PRODUCT UPDATE

- Core Series High Speed HDMI® Cable with Ethernet

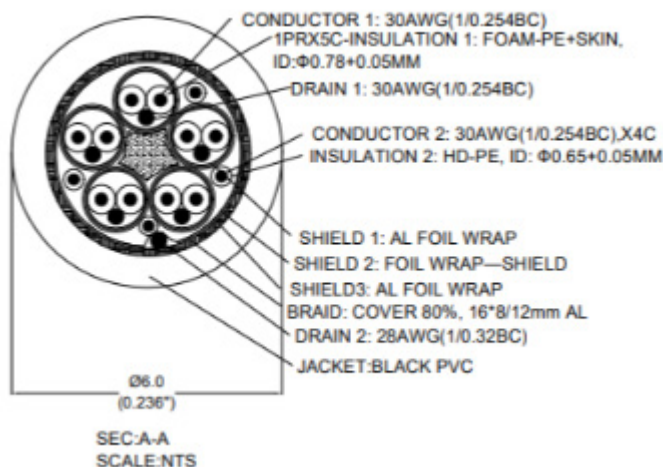
- Raw cable conductor material** changed from **stranded copper** to **solid copper**.
- Minimum Bend Radius of 1ft to 10ft cables** (CG50606-CG50610, CG56781-CG56784, C2G21000-C2G21005) changed from **R42mm** to **R48mm**.
- Minimum Bend Radius of 10ft and 12ft cables** (CG50611, CG50612) changed from **R51mm** to **R58.4mm**.

We have upgraded to solid copper conductors to deliver better performance and reliability for HDMI connections. Due to the change, the cable is now slightly stiffer than the old version. If you require a more flexible HDMI cable, please consider our Plus Series Slim Flexible (CG41361-CG41364, C2G41398) or Performance Series Ultra Flexible (C2G10373-C2G10386, C2G10399-C2G10402) product lines.
